STAFF REPORT

2232-Y13-10, SEA 90-S-021

SULLY DISTRICT

PROPOSAL: 130-foot tall lattice tower structure and associated equipment in a 60-foot by 60-foot area with 8-foot fencing.

Figure 10: Proposed landscape plan.

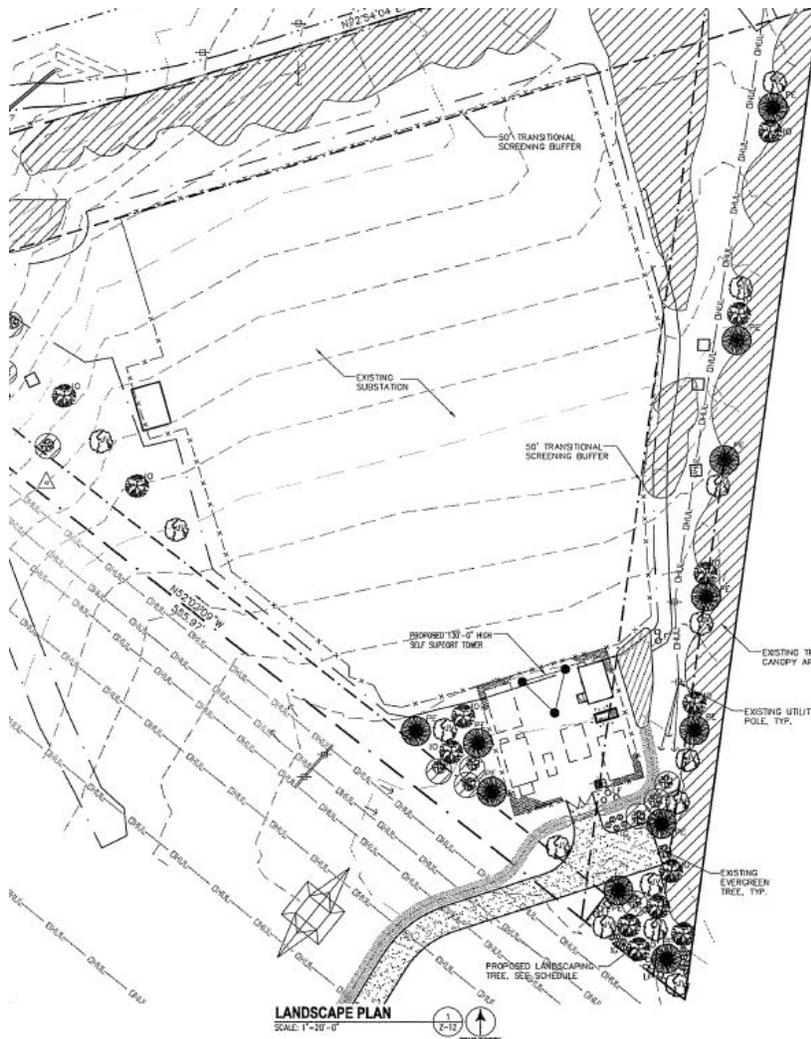
Requested Modifications - The applicant has requested a modification of the transitional screening requirements, in accordance with Sect. 13-305 of the Zoning Ordinance, to consider the proposed landscaping shown on the SEA Plat as meeting screening requirements, and requests that the existing 11-foot chain-link fence (with slats), surrounding the existing substation, and the proposed 8-foot chain-link fence (with slats), to surround the telecommunications compound, be accepted in lieu of required barrier fences along the property lines. The proposed Landscape Plan and calculations (Sheets Z-12 and Z-13) identify the required screening buffer areas, and further describe the modifications requested. The proposed 8-foot enclosure fencing is detailed on Sheet Z-7. Similar modification requests were approved with the prior SE (in 1995).

Subject to the proposed condition, staff is comfortable with the requested Transitional Screening and Barrier modifications.

Figure 11: Existing stormwater management features.

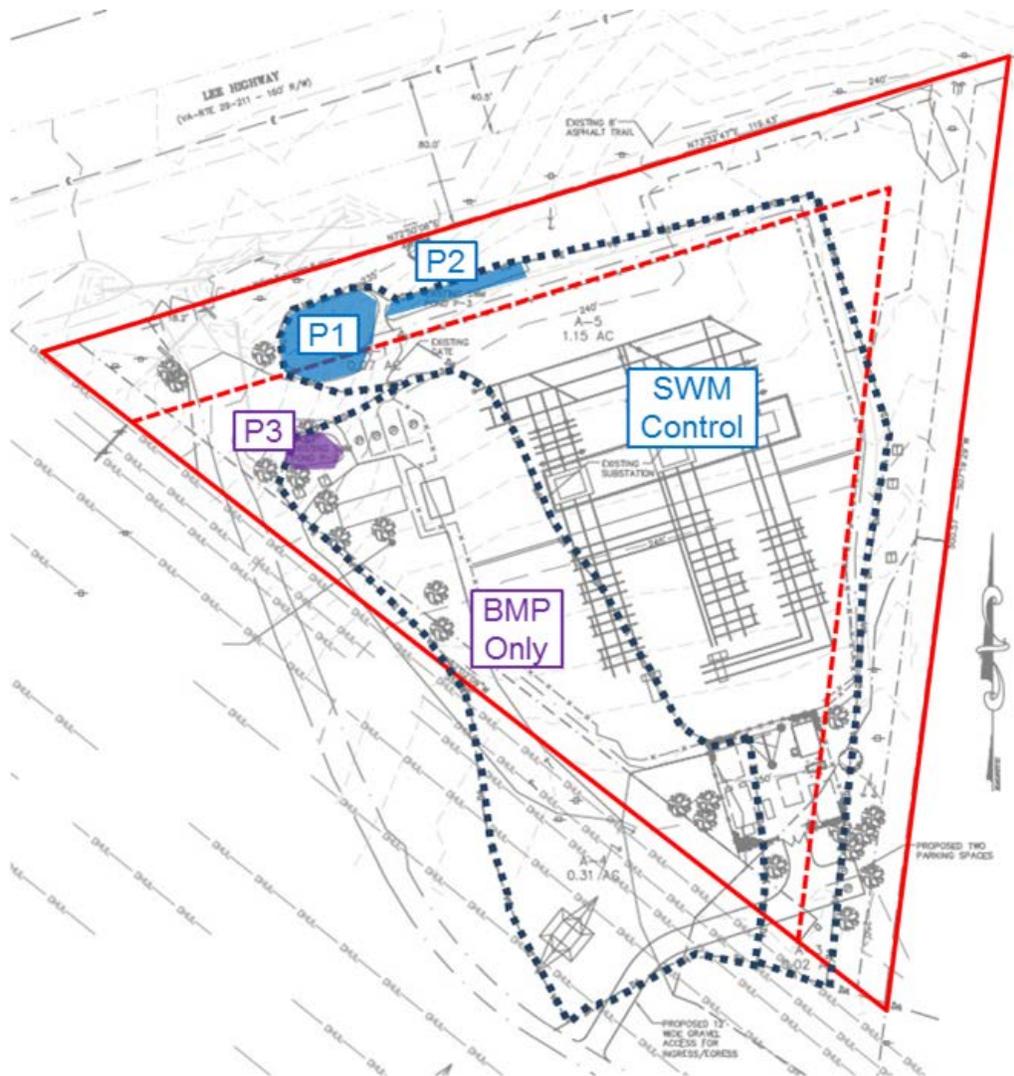
Installation of the existing substation infrastructure included a detention pond (labeled Pond P-1 on the SEA Plat), as well as two upstream BMPs (Ponds P-2 and P-3) to meet detention and water-quality requirements, at that time. The currently proposed improvements would result in additional impervious surface area, which would require stormwater control and treatment sufficient to meet current regulations.

Initial submittals of the SEA Plat included no proposed SWM features and indicated that waivers would be pursued at site plan stage, which staff did not support. Subsequent revisions to the SEA Plat have addressed SWM requirements on Sheets Z-14 and Z-15, though Sheet Z-1 still references outdated information indicating a lack of proposed SWM facilities. Staff has proposed a development condition that clarifies that SWM facilities, in conformance with County Ordinances, will be required at the time of site plan review.

Figure 12: Proposed stormwater management facilities.

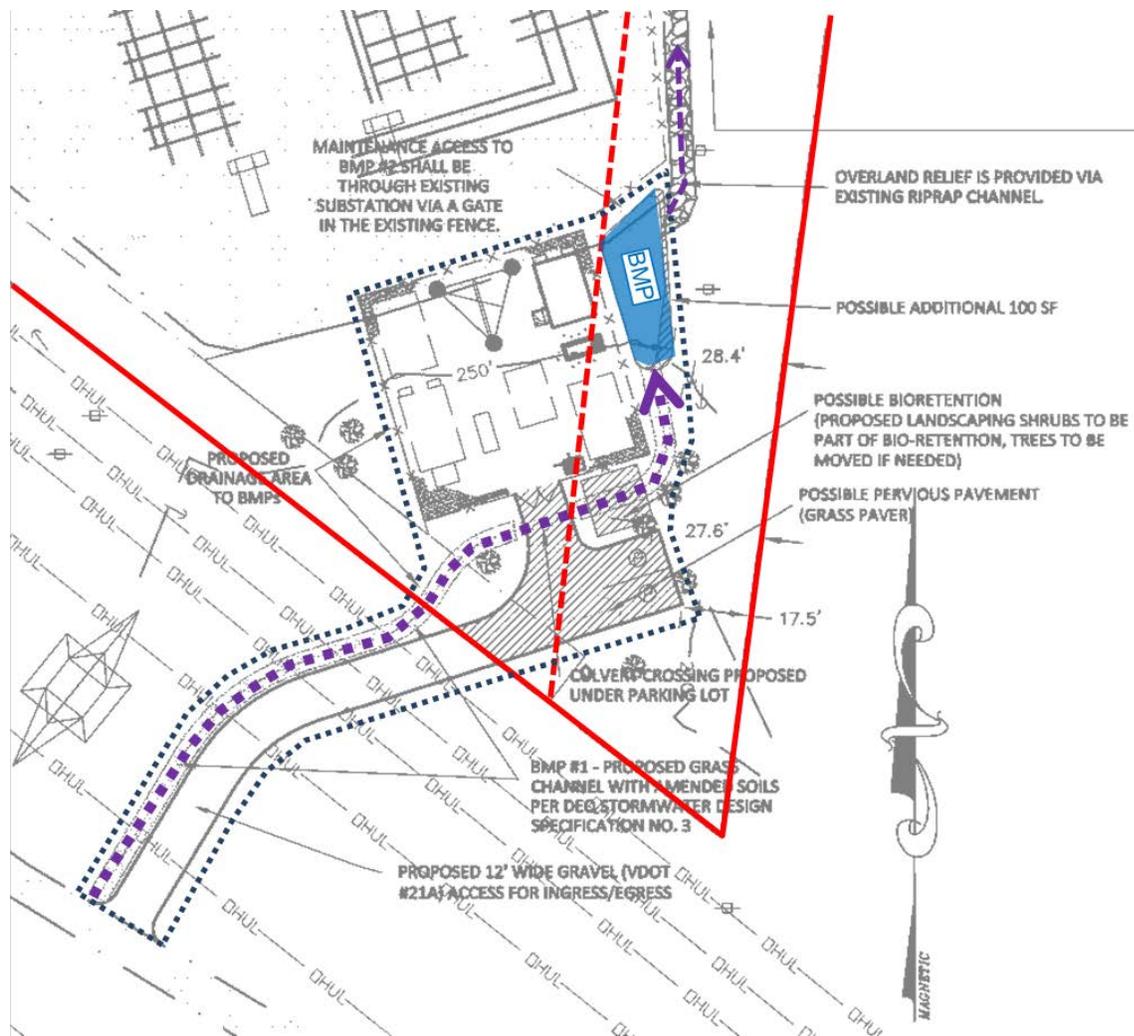
The current SWM proposal (as depicted on Sheet Z-14, and described on Sheet Z-15) consists of a grass-lined channel, adjacent to the proposed access drive, which would

convey all runoff from the impervious areas to a bioretention facility for treatment. Overland relief would be provided via an existing rip-rap channel on the site.

STAFF ISSUE - Staff supports the general concept of intercepting and treating runoff from the proposed new impervious areas upstream from the existing site infrastructure, so as not to adversely impact the existing SWM facilities onsite, but questions aspects of the SWM Design Narrative (Sheet Z-15) appearing to claim gravel areas as being pervious, and utilizing “void” areas of the gravel for stormwater storage. County SWM regulations, would generally treat all gravel areas as completely impervious, which might result in a higher runoff volume than what is projected, and the requirement for additional treatment facilities at the time of site plan review.
